SEWAGE DISPOSAL SYSTEM

SUBDIVISION Chapel Woods ROAD 11825 Linden Chapel LOT 9

CHAPEL WOODS
SECTION II AREA I
PLAT #7185
LOT 9 SEWAGE EASEMENT
VARIANCE

Foundation Location Survey of # 11825 LINDEN CHAPEL ROAD

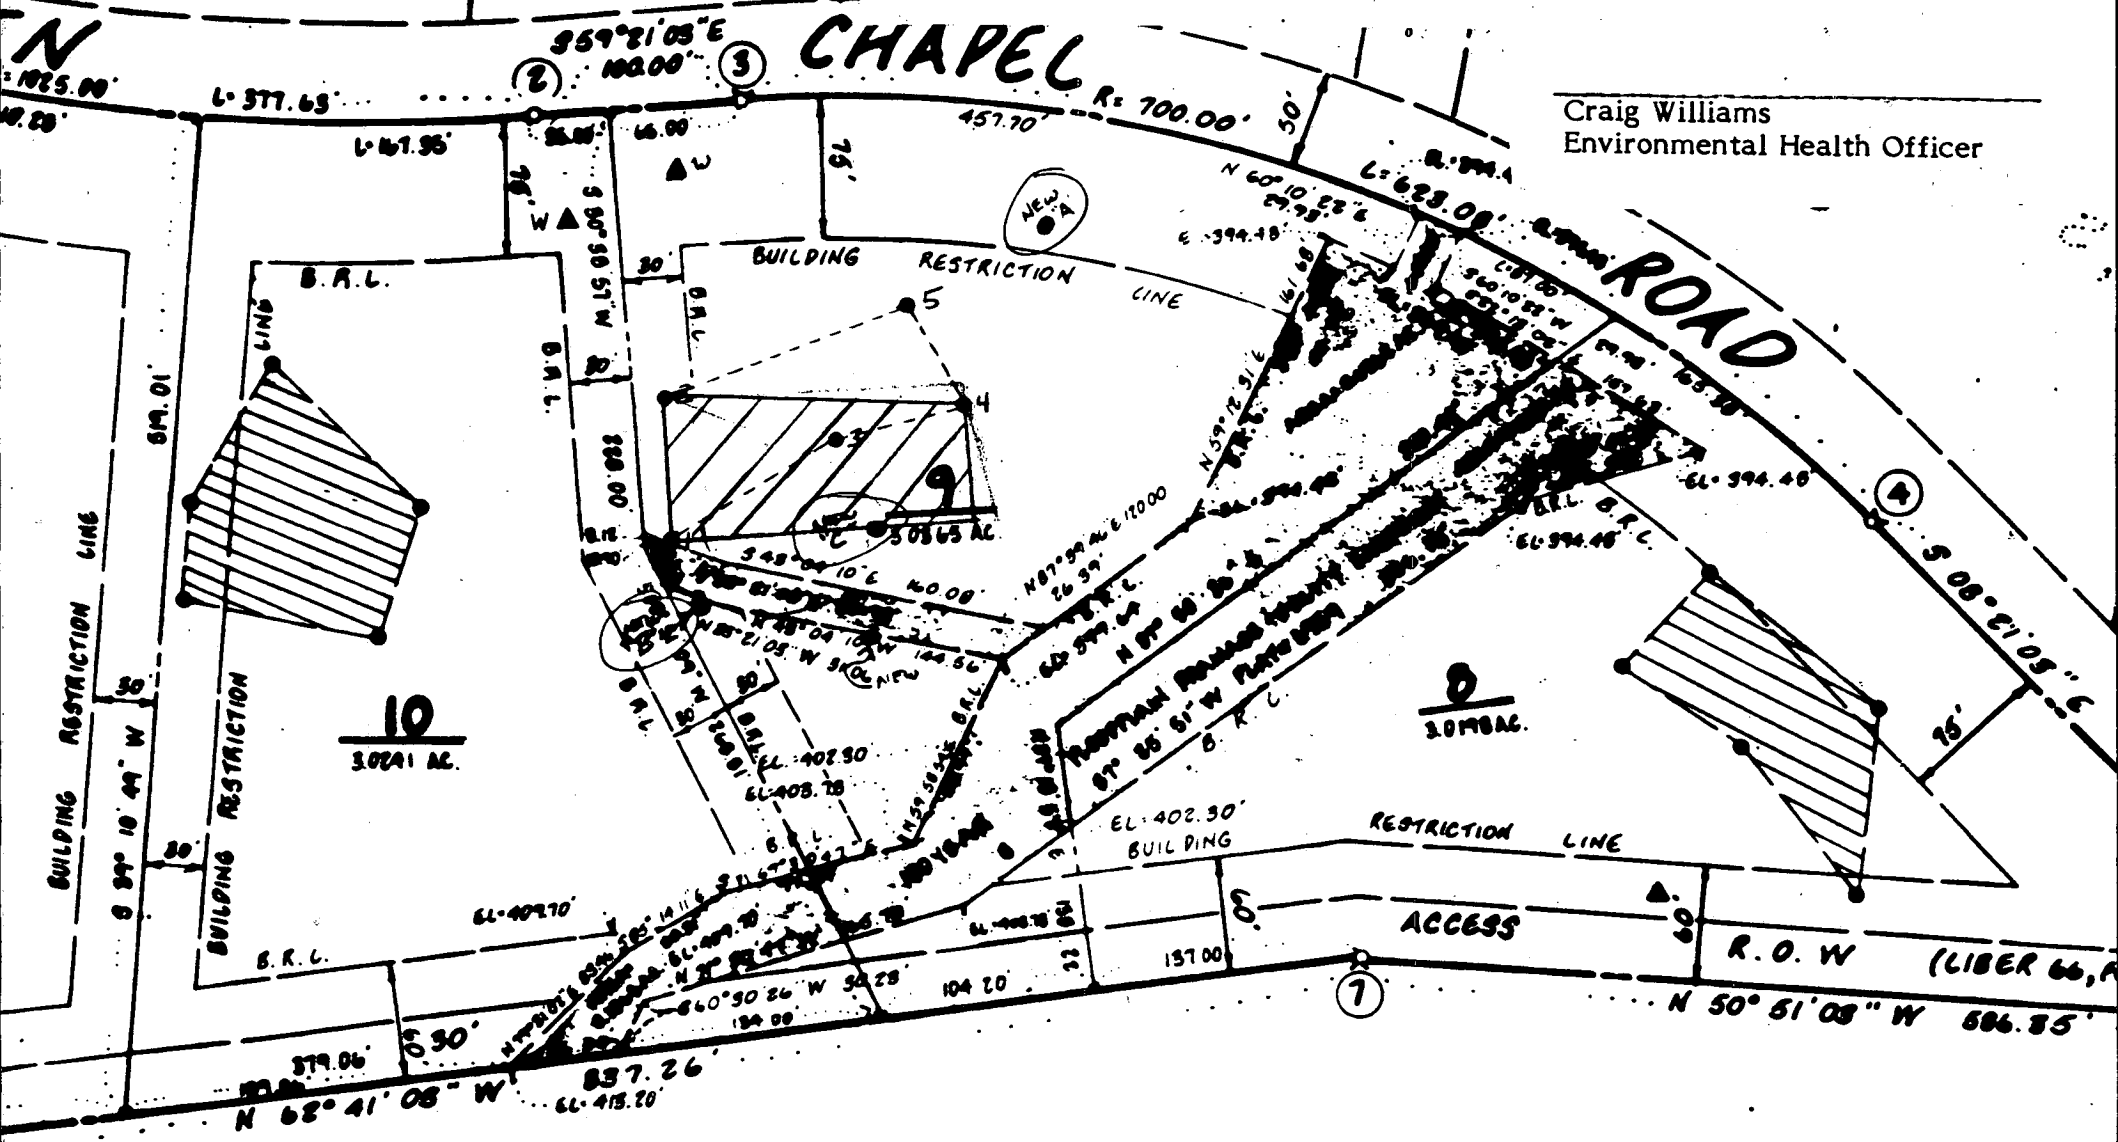
The revised septic easement shown hereon is acceptable to the Howard County Department of Environmental Health and Mental Hygiene and may be used in place of the area reserved on recorded Plat #7569

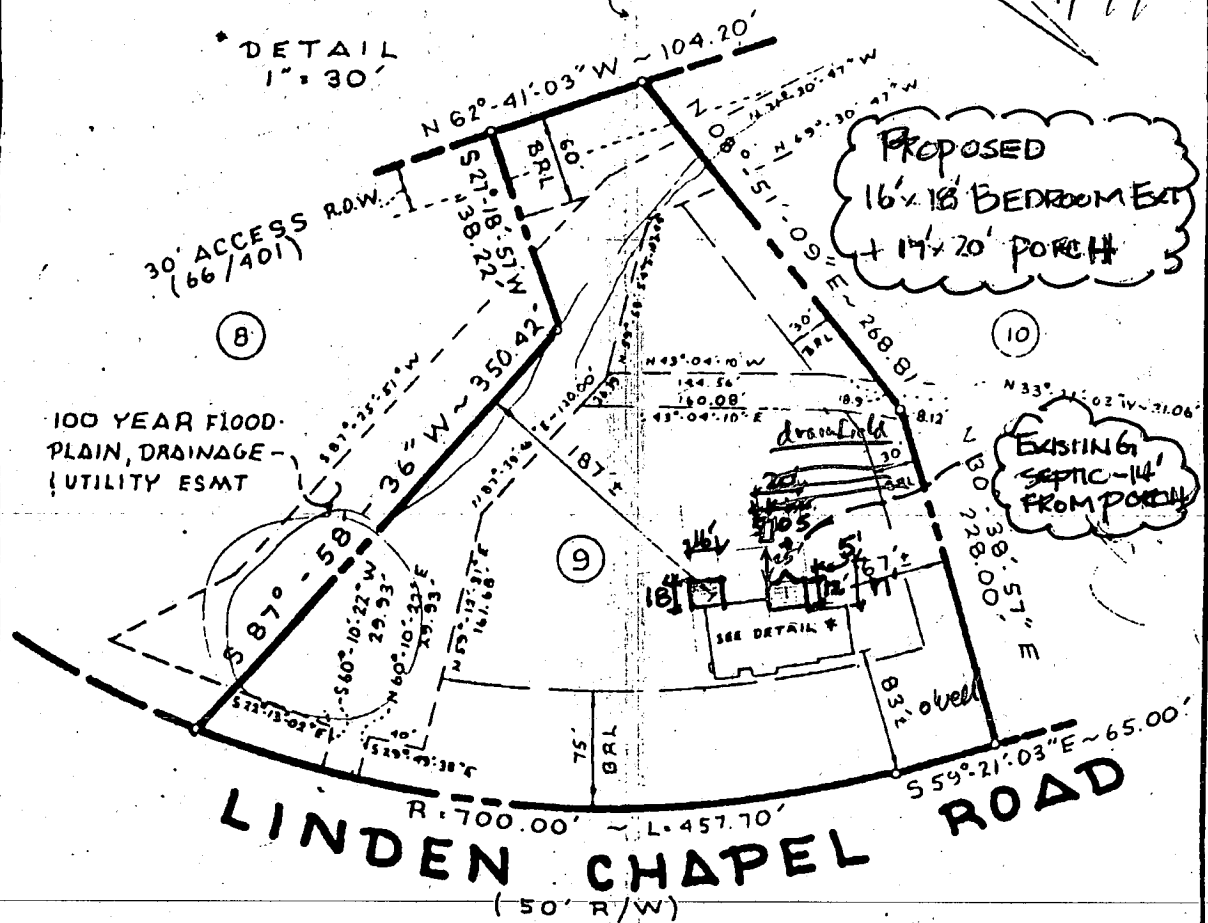
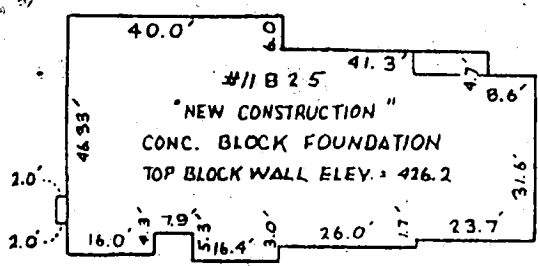
B 00 12 47 49
 11825 Linden Chapel Rd
 Extending existing Bedroom
 + porch - No change in # Bedrooms
 No impact on well or
 Septics. Recommended Approval.
 AP 6/8/00
